KING WILLIAM STREET BEACON AND GATE **PUBLIC ART PROJECT**

Call for Artists ADDENDUM 01

Thursday February 13th, 2020

REVISED PER ADDENDUM 01
FEB 13/2020

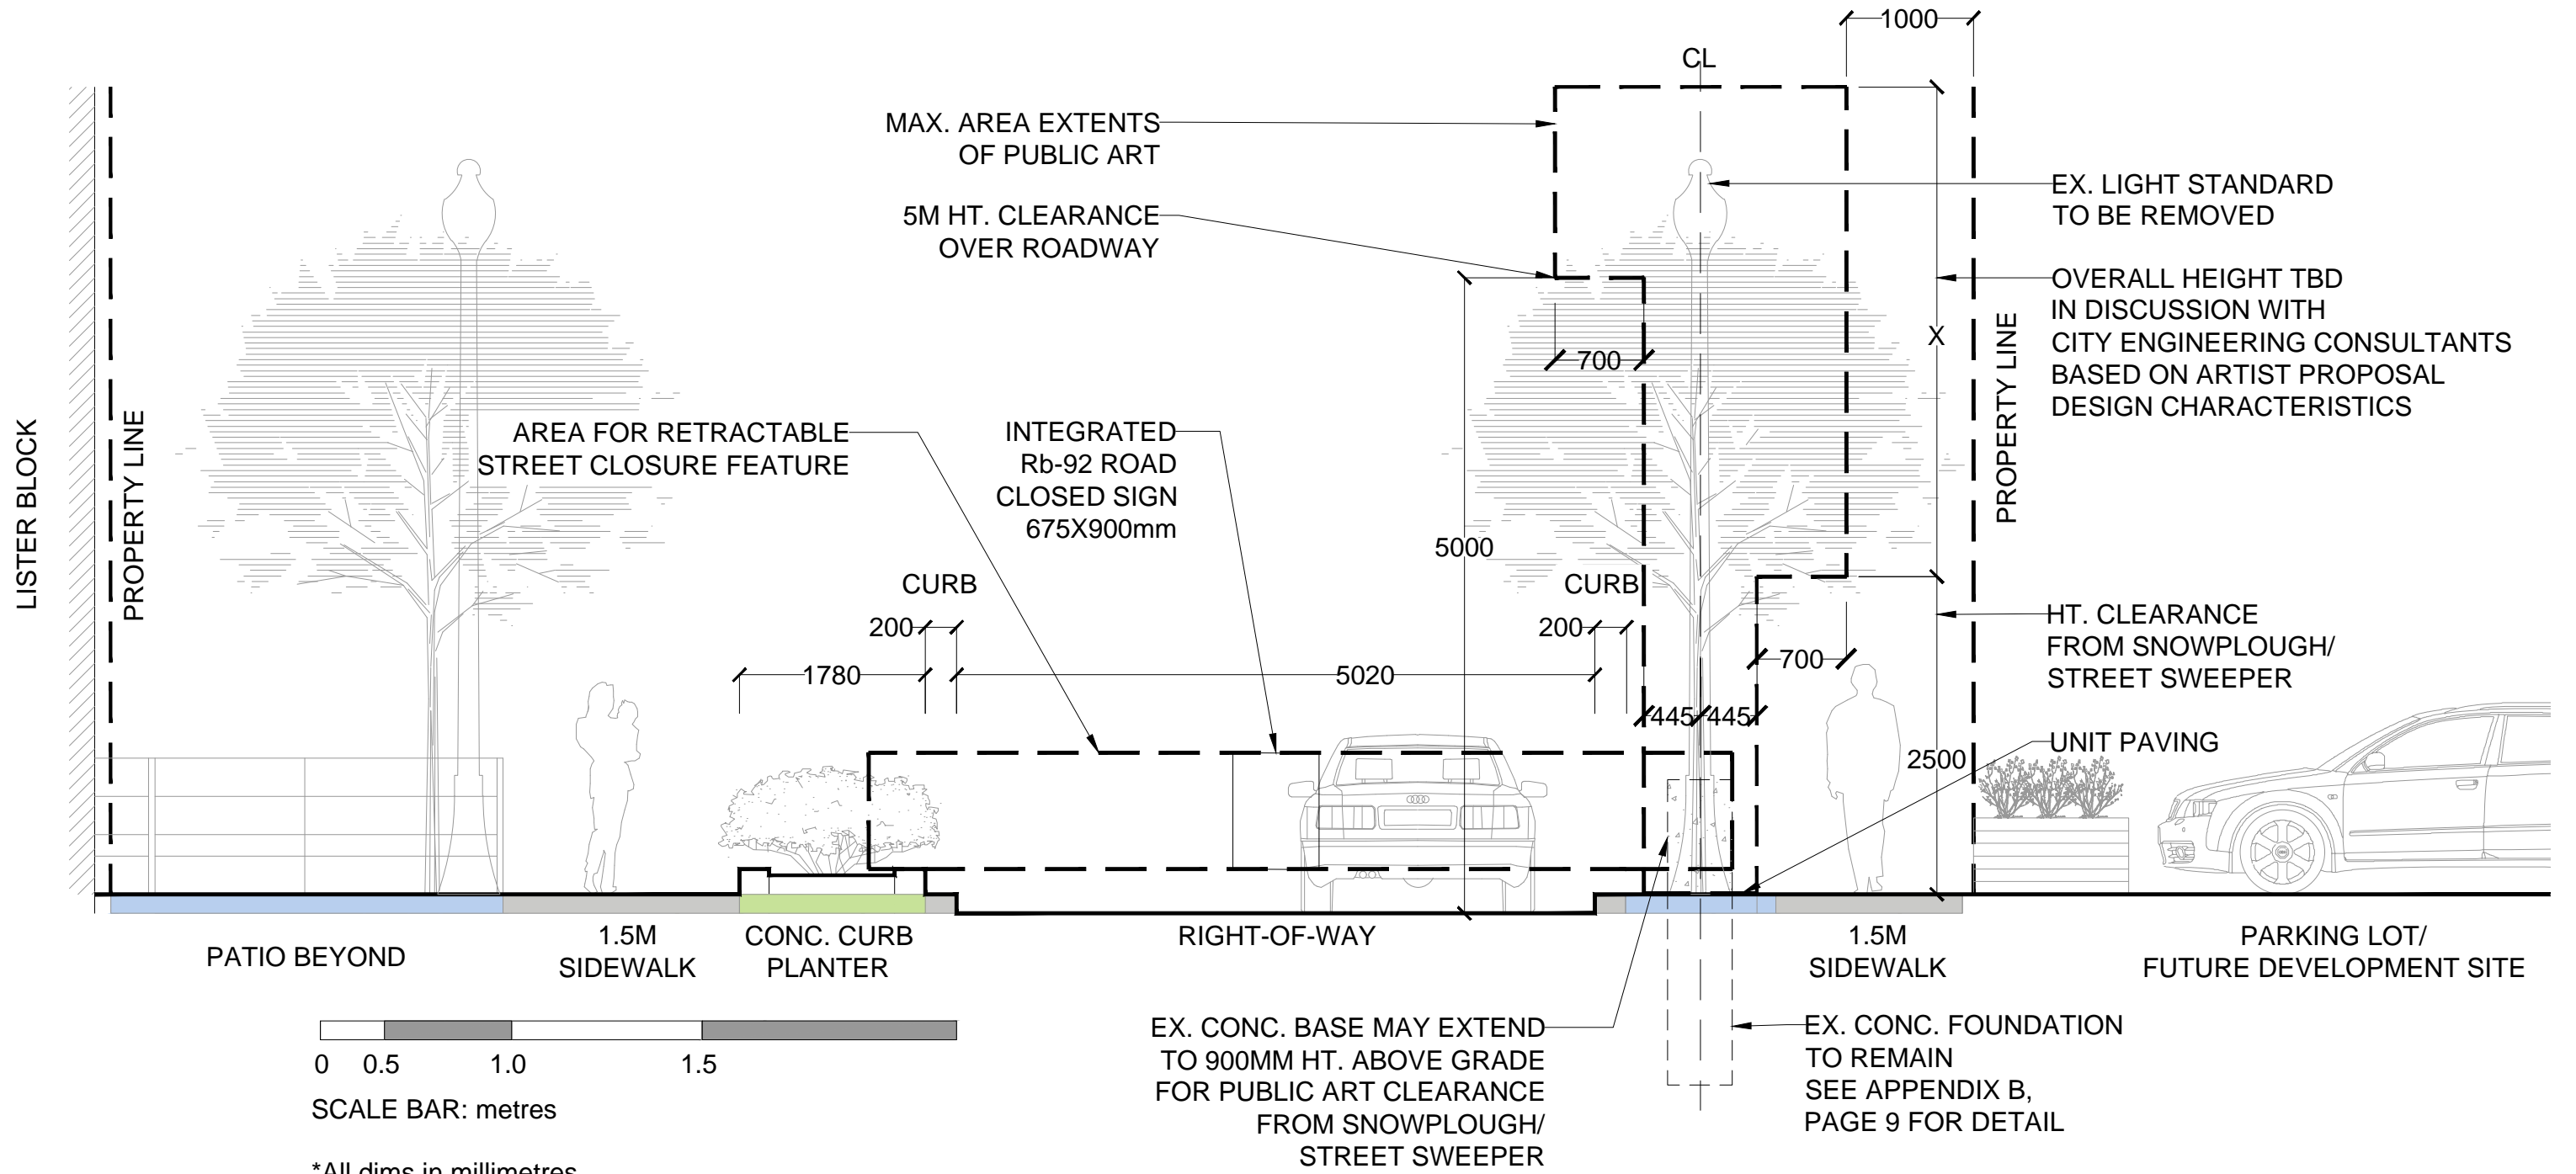
2.0 Under Call for Artists, Appendix B, **delete** page 7 and **replace** with the attached. Please note: additional dimensioning for roadway and planter on the north side of King William Street. Planter width varies east to west.
